**LANDSCOPE (MAURITIUS) LTD**  
**INFRASTRUCTURE WORKS AT COTE D'OR**  
**REF No.: LM-CD-AP24-150**

**ADDENDUM NO. 4**

**Date: 07<sup>th</sup> June 2024**

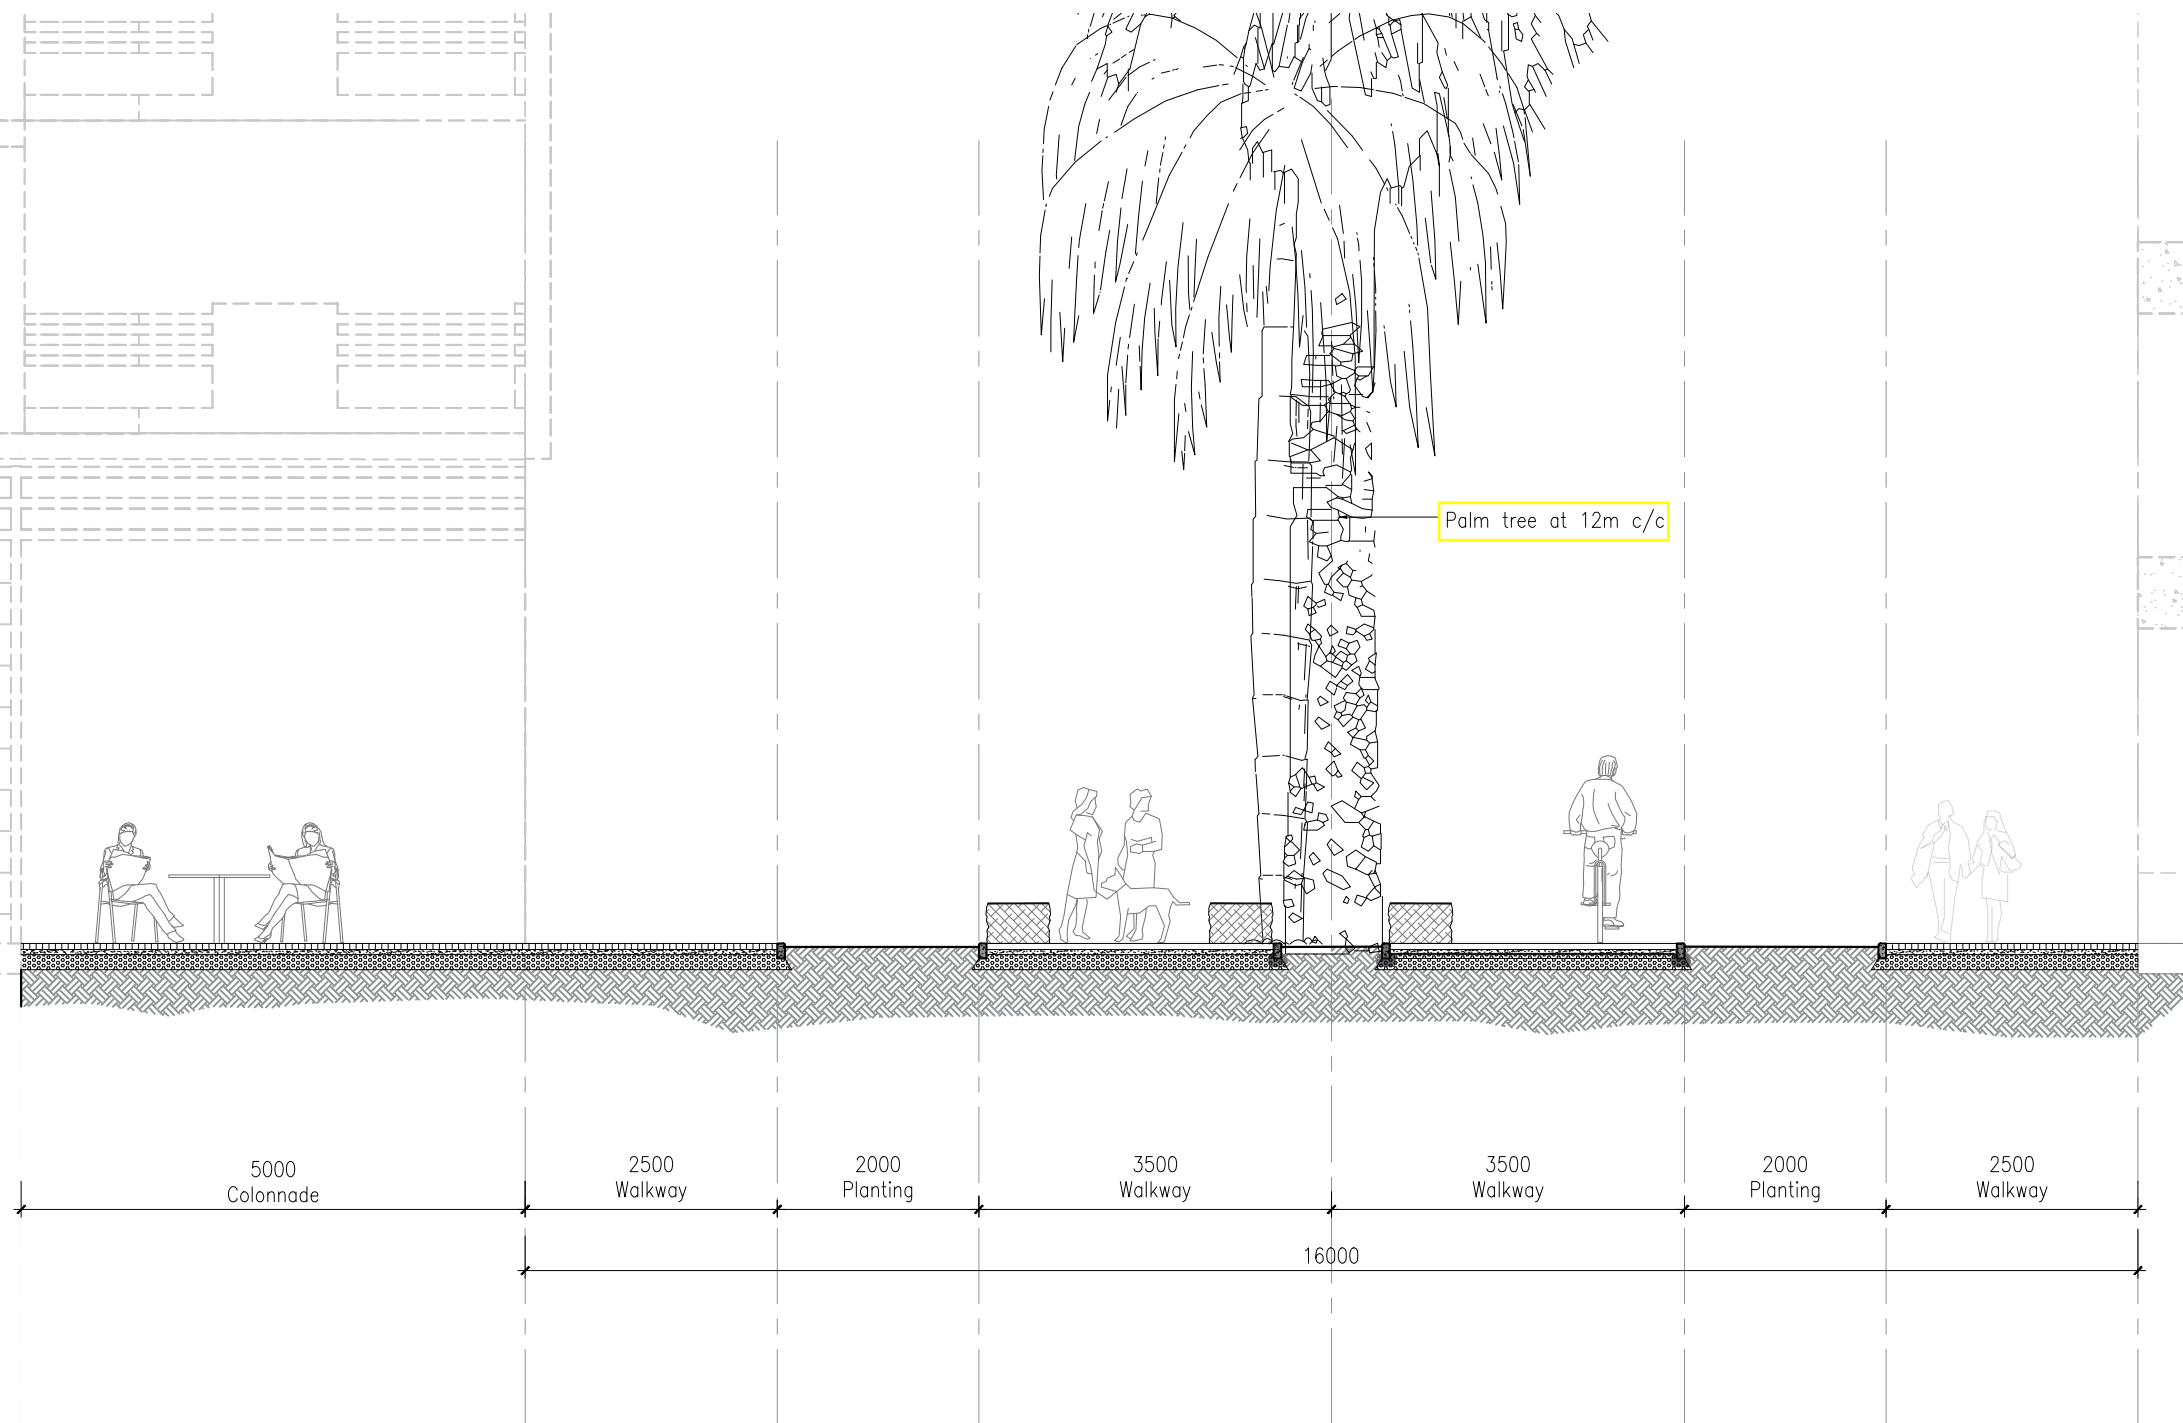
| SN  | Original Queries by Bidders  | Reply from Employer   |
|-----|--|---|
| 7.  | We refer to the above-mentioned tender and would be grateful if you could provide the typical road cross-sections across walkway 1, walkway 2 & metro line   | Bidders are hereby informed that 23140-TD-3TP113 and 23140-TD-3TP114 marked addendum No. 4 now forms part of volume 3 of 3 of the bidding documents as enclosed in <b>Annex A</b> |

23140-TD-3TP712

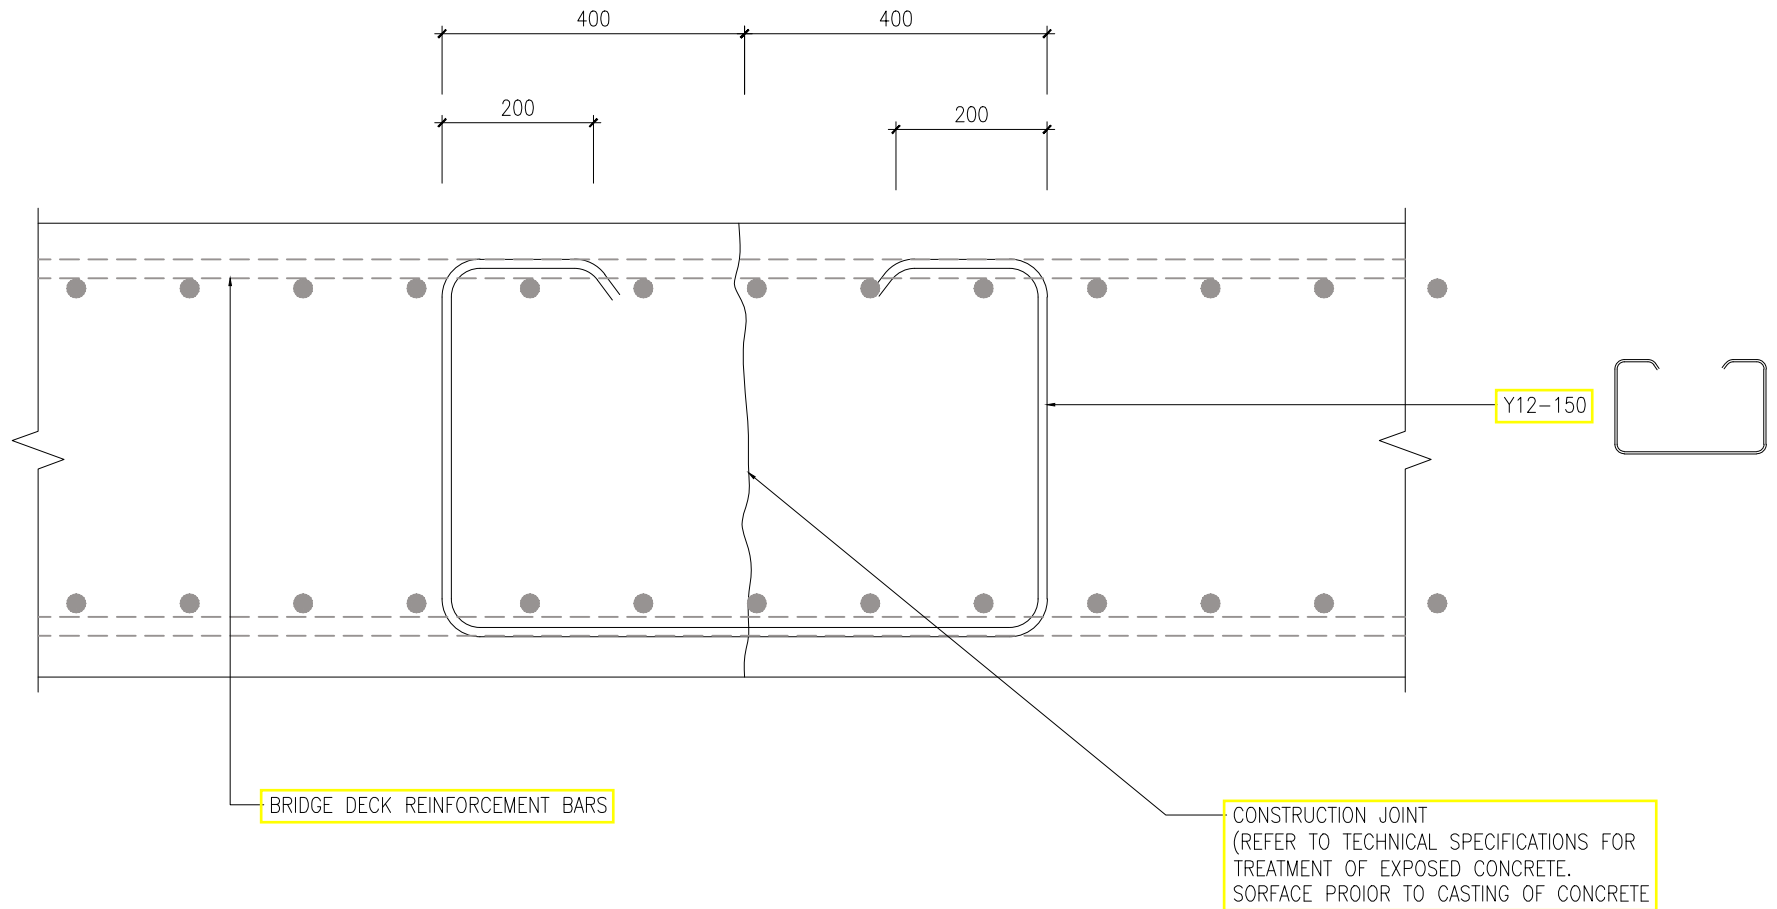
| SN  | Original Queries by Bidders  | Reply from Employer   |
|-----|--|---|
| 10. | Lot 1 – Bill No. 14 – Bridge Construction – item 1405E – construction joints. Please provide the detail of joint   | Bidders are hereby informed to refer to drawing 23140-TD-3TP712 marked addendum No. 4 as enclosed in <b>Annex B</b>   |
